MONTGOMERY COUNTY HISTORIC PRESERVATION COMMISSION
STAFF REPORT

Address:	19820 White Ground Road, Boyds	Meeting Date:	1/8/2025
Resource:	Non-Contributing Resource Boyds Historic District	Report Date:	12/31/2024
Applicant:	Danilza Garcia	Public Notice:	12/25/2024
Review:	HAWP Revision	Staff:	Laura DiPasquale
Case Number:	1050805	Tax Credit:	No
Proposal:	Revisions to previously-approved foundation cladding on new house and tree removal

Figure14: Proposed front elevation. The application proposes to retain the stone cladding on the front elevation and on the porch sides.

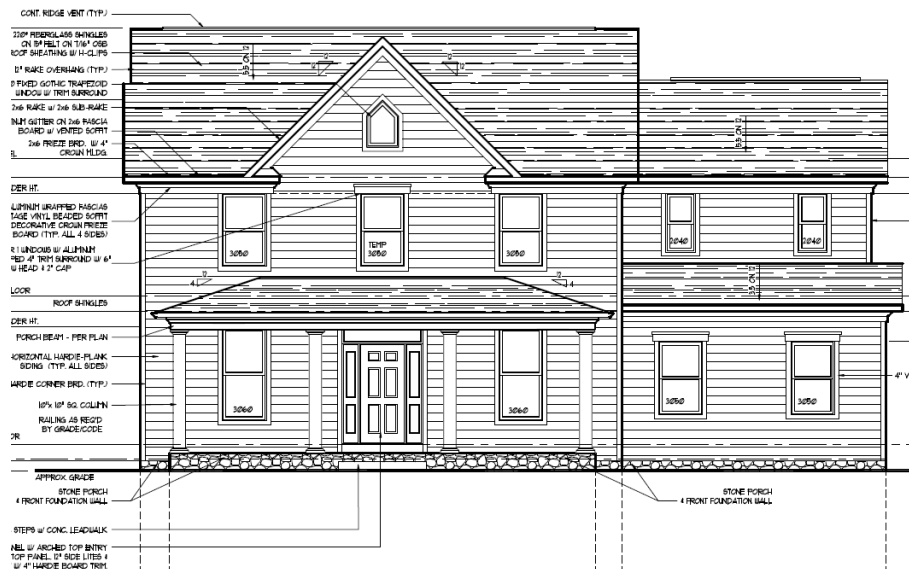
Staff supports the use of stone around the base of the porch as proposed and previously-approved, but recommends that the transition from the stone veneer along the front of the main house to the proposed stamped brick on the sides of the main house be amended. Staff finds that the transition, which is not detailed in the submission, will present as incongruous and call attention to the false nature of the materials (*Figure15*). Staff recommends that the applicants utilize a consistent material for the front and sides of the main block. Staff finds that the use of a consistent textured masonry material is compatible with the character of the historic district, where similar building materials are common, in keeping with Chapter 24A-8(b)(2) and will not seriously impair the historic or architectural value of surrounding historic resources of the character of the district, in keeping with Chapter 24A-8(b)(1). Furthermore, given the Non-contributing categorization of the property, staff finds that the HPC should be lenient in its judgment of plans for the property, pursuant to Chapter 24A-8(d), finding that the proposal will not seriously impair the value of the surrounding historic resources or character of the district.

1. The same stamped concrete must be used around the base of the entire main block, including the front elevation. The porch base cladding may remain as proposed.
2. Pictures of the specific trees to be removed will be provided to staff.

Figure16: Tree survey showing the location of the trees proposed for removal.

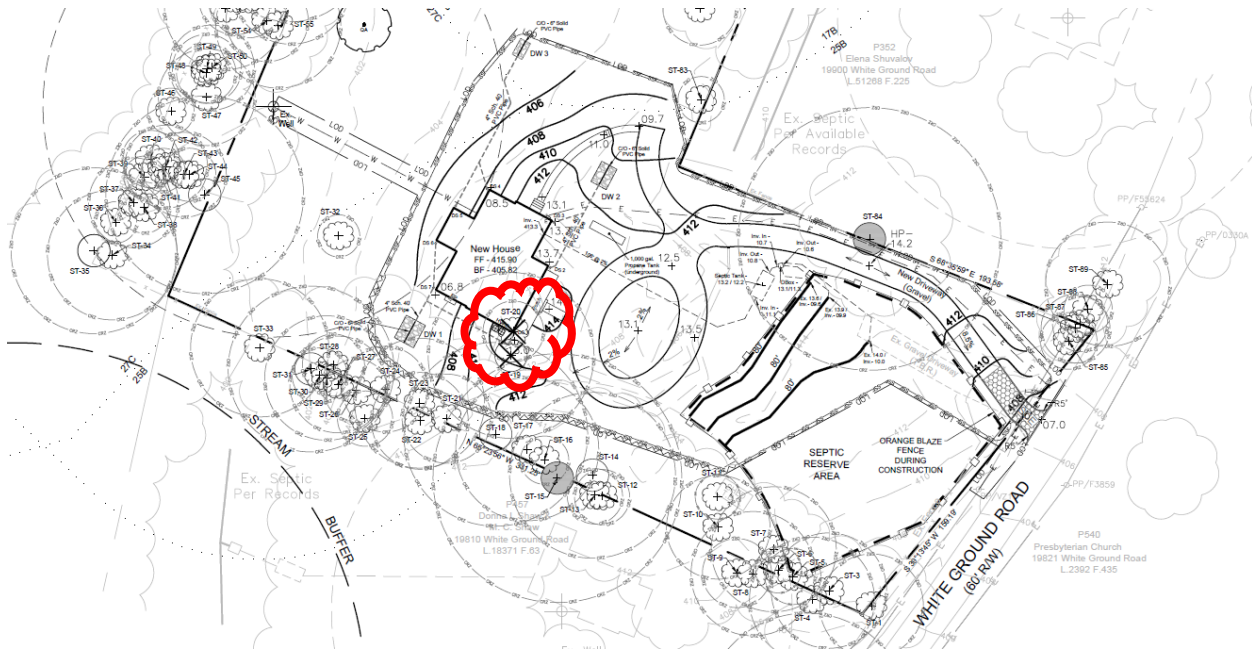
Staff also supports the removal of two trees at the center of the property, adjacent to the proposed

construction. The application identifies the trees to be removed as a 24.0” DBH Tree of Heaven in poor condition “with poison ivy, phototropic lean, adventitious limbs, unbalanced canopy, broken dead limbs with decay,” and a 7.6” & 8.8” Boxelder in moderate-poor condition with “canker with decay, basal rot, adventitious limbs.” The *Vision of Boyds* identifies large, impressive trees that line White Ground Road as a character-defining feature of the district. Staff finds that the trees proposed for removal, which are set approximately 195 feet from the public right-of-way, are not character-defining features of the district, and that their removal will not seriously impair the character of the historic district, satisfying Chapter 24A-8(b)(1) and 24A-8(d).
